Table 1: Responses to Technical Advisory Committee (TAC) Review Comments

Subject: **AECOM's Response to the Technical Advisory Committee (TAC) Questions and Comments related to Air Quality: CanWhite Vivian Sand Processing Facility Project (File 6057.00)**

Subject: Preliminary Traffic Projections – Proposed Vivian Sand Facility Project

RE: Vivian Sand Facility Project – Environment Act Proposal (EAP) Application File: 6057.00: Updated Rail Loop Design Information

Figure 1: Three-Dimensional representation of buildings and point emission sources (The red-coloured bars protruding from the sides of the silos represent horizontal stacks, at a height corresponding to the top of the red bars. Other red bars represent actual stack sources.)

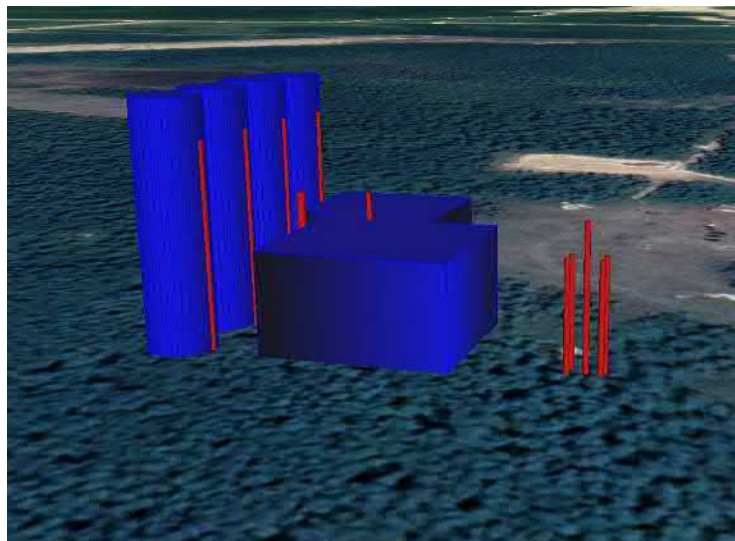
The proponent did not provide any information regarding building located within the facility. Was the building-downwash effect taken into account in the modeling?

Building downwash was considered in the modelling. However, only silos and the dry processing building were included to the model due to their proximity to the point sources. Figure 5 in the Air Quality Assessment Report (Appendix B in the EAP) presented the location of the building and the silos with respect to emission source. Figure 1 below also provides a three-dimensional image of the buildings and stack sources included in the Building Profile Input Program – Prime Version (BPIP-PRIME).

Figure 1 – Trip Distribution Schematic at PR 302/PTH 15 Intersection

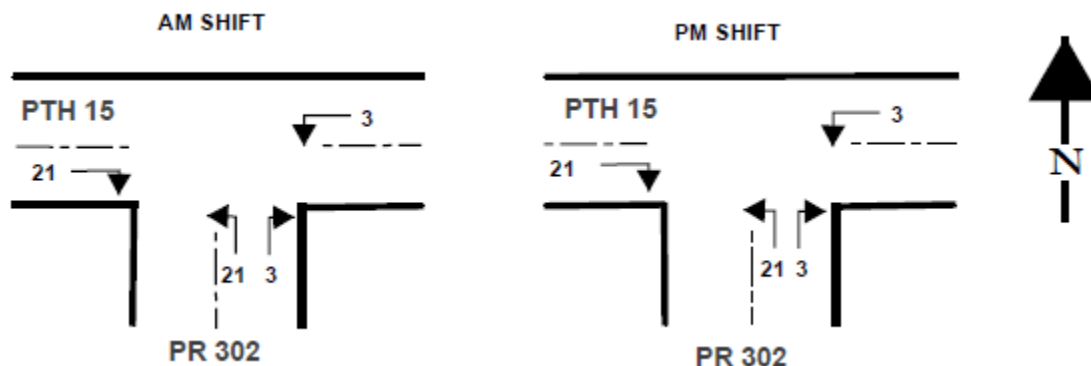
8	<i>Traffic generated by this development may have an impact on the traffic operations of PR 302 and PTH 15. Therefore, we require the developer to provide some preliminary traffic projections. Please contact Karen Toews (204) 945-0324 or Karen.Toews@gov.mb.ca. Based on this information, our department will determine if a more detailed Traffic Impact Study is required. If required, this study is to be prepared by a qualified engineer and will determine what impact the traffic generated by this development will have on the traffic operations at this location and what, if any, on highway improvements will be required.</i>	As requested, preliminary traffic projections are provided in Attachment B . CanWhite will provide a more detailed Traffic Impact Study if required.	N/A

For this analysis it is assumed that 80% of the workforce will be arriving/departing at the PR 302 and PTH 15 intersection from/to the west. It is further assumed that the employees from Richer would comprise approximately 10% of the vehicle traffic and would arrive/depart to the south along PR 302. For employees from Vivian it is assumed that they will comprise approximately 10% of the vehicle traffic and arrive/depart at the PR 302 and PTH 15 intersection from the east.

Figure 1

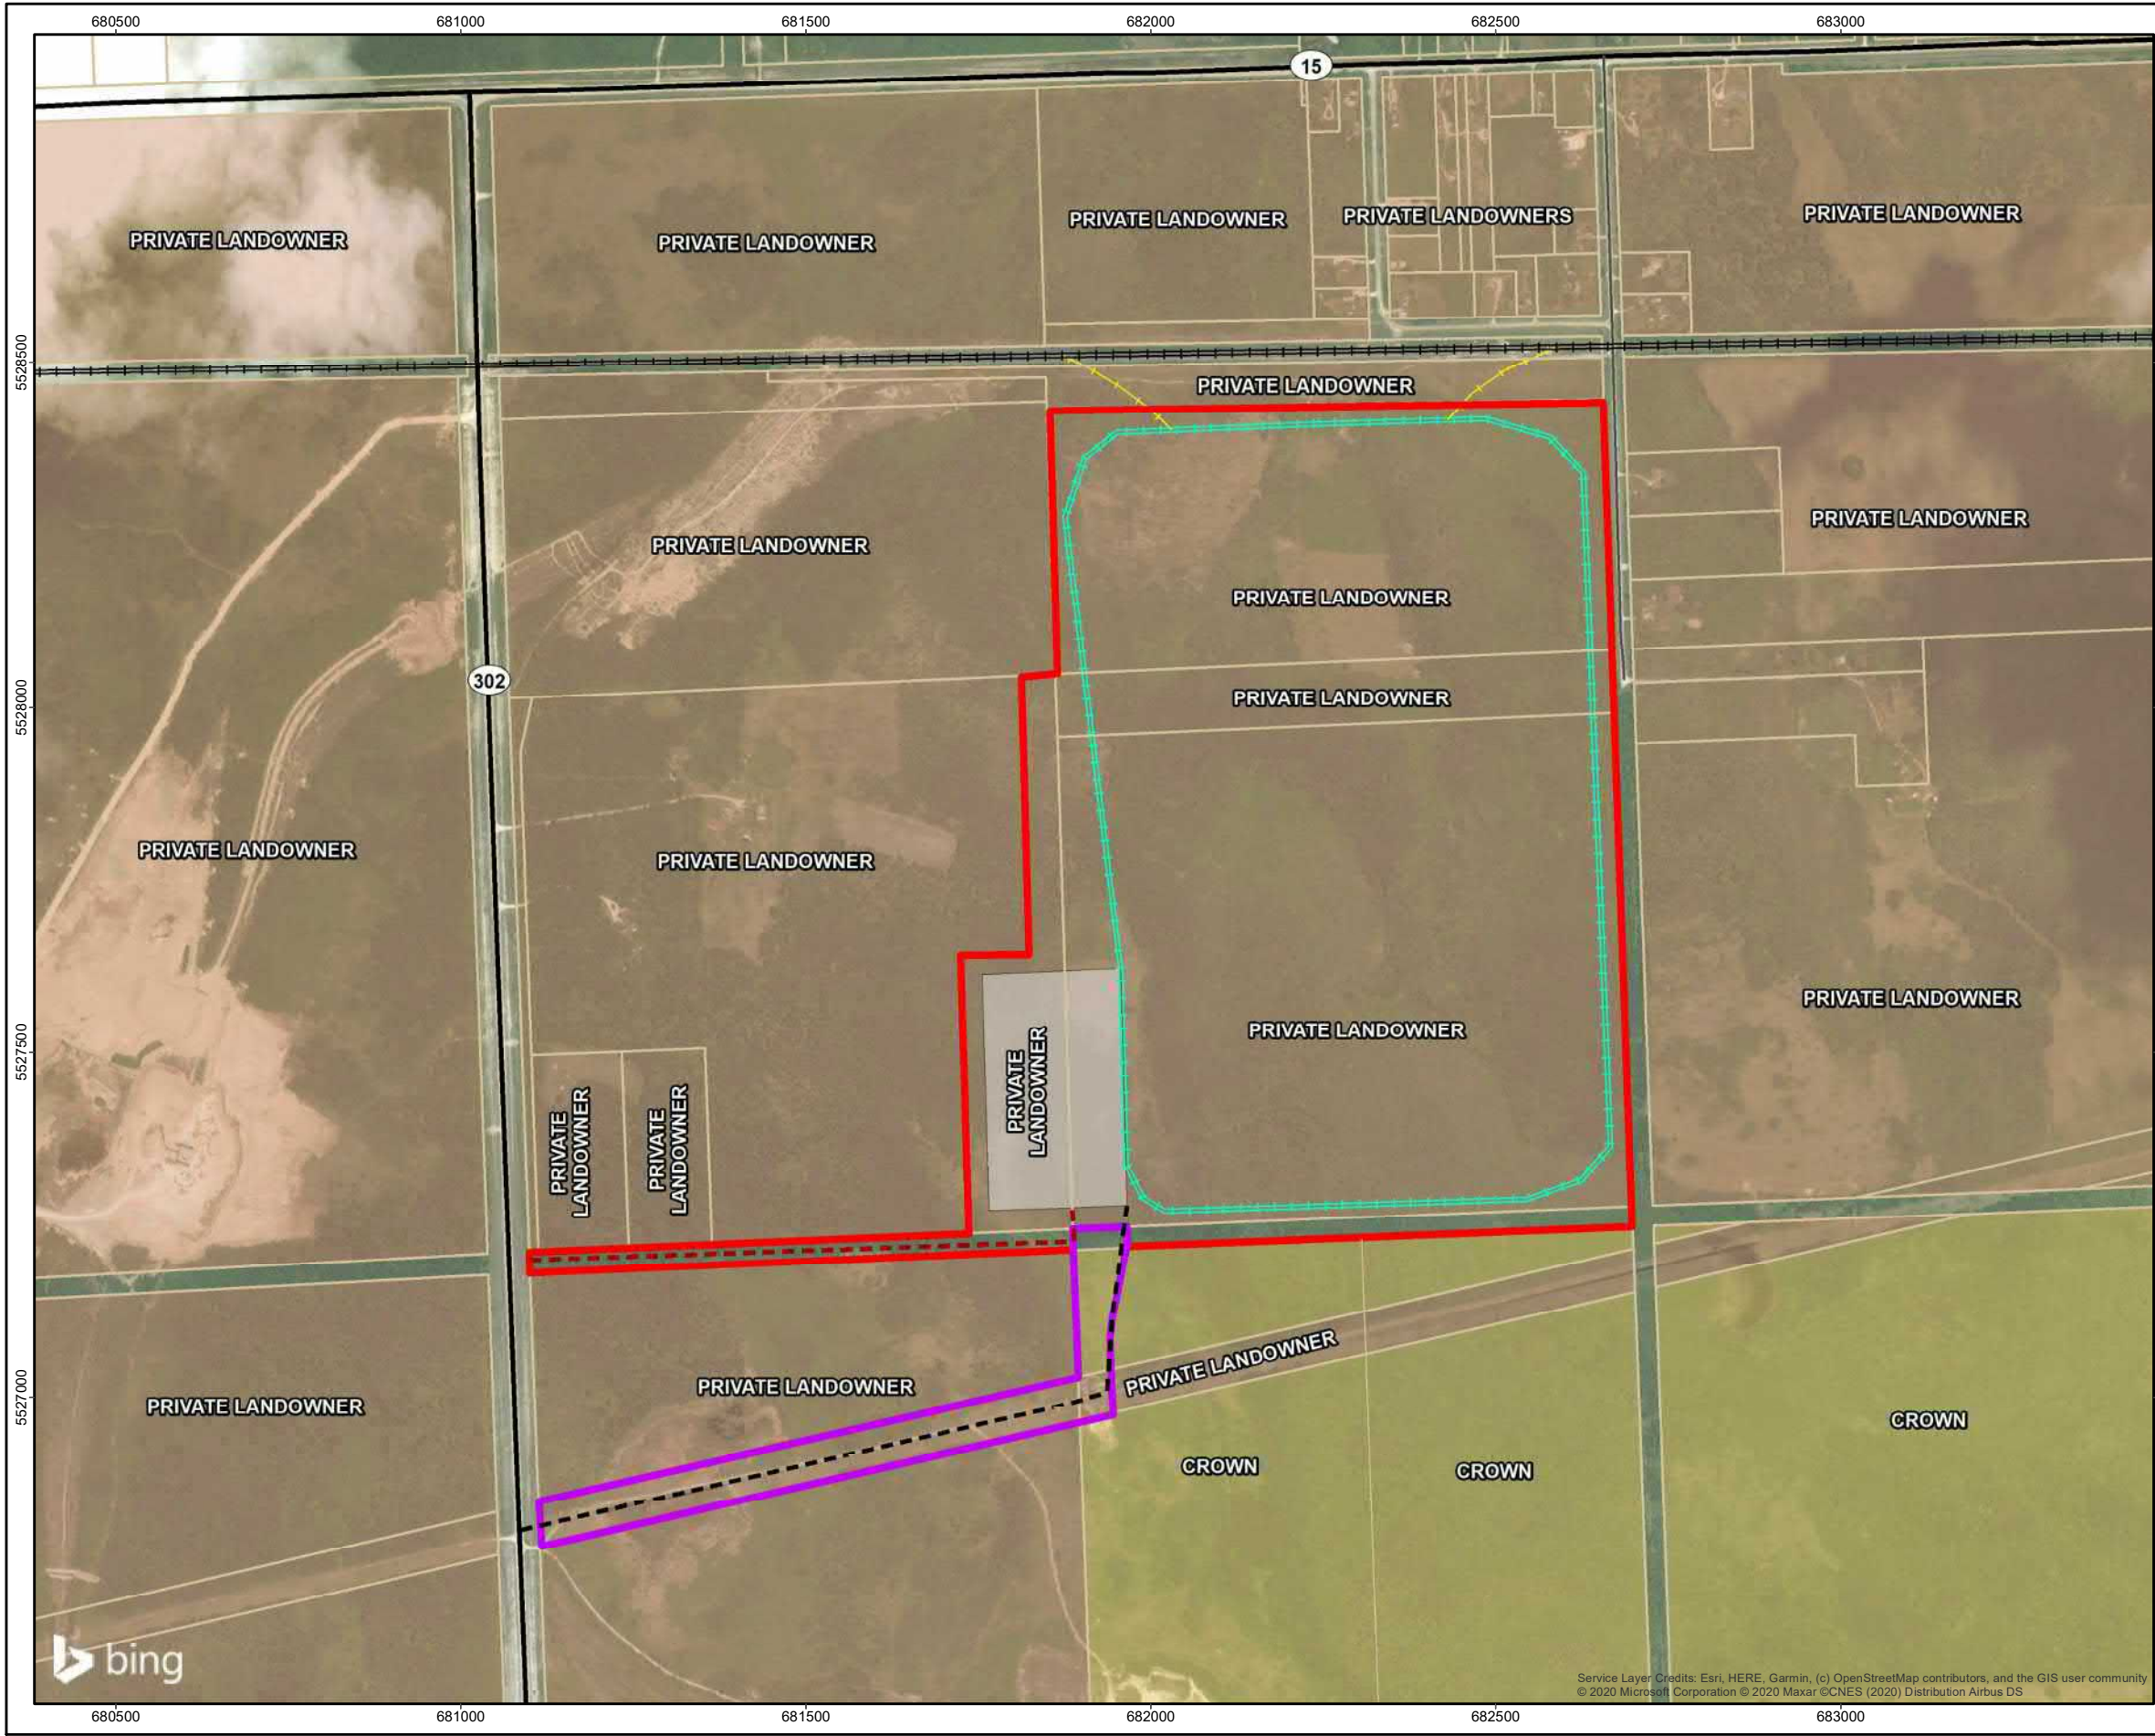
18	<i>Our records indicate that the identified location of the processing facility overlaps with multiple known breeding observations of the golden-winged warbler (listed as Threatened under the federal Species at Risk Act and provincial Endangered Species and Ecosystems Act). The proponent should be required to consult with the Wildlife and Fisheries Branch to develop a clearing strategy that maintains golden-winged warbler nesting habitat in the project area.</i>	<p>CanWhite will develop and comply with any other mitigation and monitoring plans, or clearing strategies, that are included as requirements within an Environment Act Licence for the Project. As indicated in Section 6.5.2 (Wildlife), Vegetation clearing will take place outside of the spring and summer months to the maximum extent feasible to avoid disturbance to breeding birds. Vegetation clearing will not take place during the peak breeding bird season for this 'Zone B4' area: April 25 – August 15 (when 90% of bird species in the area are known to nest); pre-clearing nest searches will be conducted no more than 5 days prior to clearing during the 'shoulder' nesting season outside of this 'peak' nesting timeframe (i.e., April 14 – 24 and August 16 – 24), as needed. As indicated in Section 6.5.1 (Vegetation), areas disturbed during Project construction and not required for Project operations will be allowed to revegetate naturally and will be augmented using an approved native seed mixture and native plantings if required. This mitigation is anticipated to return the vegetative cover to the pre-cleared condition over time. Although the characteristics defining 'Critical Habitat' for this species are complex and only partly understood, this species generally prefers to nest in early successional habitats (or habitats exhibiting early successional characteristics), usually with dense herbaceous growth mixed with extensive patches of dense shrubby growth along with scattered taller trees adjacent to a forested edge (Environment and Climate Change Canada, 2016).</p> <p>Given the relatively small amount of naturally vegetated area that will be cleared to accommodate the Project footprint (17 ha) it is expected that alternative nesting habitat for the golden-winged warbler is available in Regional Project Area as the above-described preferred nesting habitat is not limited only to the Project Site. Please note that although the naturally vegetated area to be cleared was indicated as 17 ha in Section 6.5.1 'Vegetation' of the EAP, that area will actually be less (approximately 13.9 ha) as clarified in Attachment C regarding the rail loop design.</p>	EAP, Section 6.5.2, Wildlife; EAP Section 6.5.1 Vegetation

Since submission of the EAP, more detailed drawings for CN Rail's review and approval for the rail loop have been completed. The more detailed rail loop design figures identified as 'Rail Concept Option 4' are attached as Figure 1 and Figure 2 for your reference and is the rail loop represented in the Noise Impact Assessment in the EAP. 'Rail Concept Option 4' also includes two short inner tracks that serve as service/maintenance track for CN Rail use only. This is a requirement by CN Rail. There are no railcar loading facilities situated over this section of track.

As shown in the attached 'Rail Concept Option 4' Figure 1, the total area including the footprint of the rail loop and all land area within the rail loop including the rail spur¹ connecting the rail loop to the existing CN Rail mainline is 47.1 ha. This area is 2.9 ha smaller than the minimum required total area of a 'railway yard' to be considered for federal review (total area of 50 ha or more), as described in the *Physical Activities Regulations* of the federal *Impact Assessment Act*. Based on the total area of the rail loop, which including the rail spur is less than 50 ha, in addition to our opinion that the proposed rail facilities for the Project do not constitute a 'railway yard', it is our opinion that this Project does not meet the criteria to trigger a federal review by the Impact Assessment Agency of Canada.
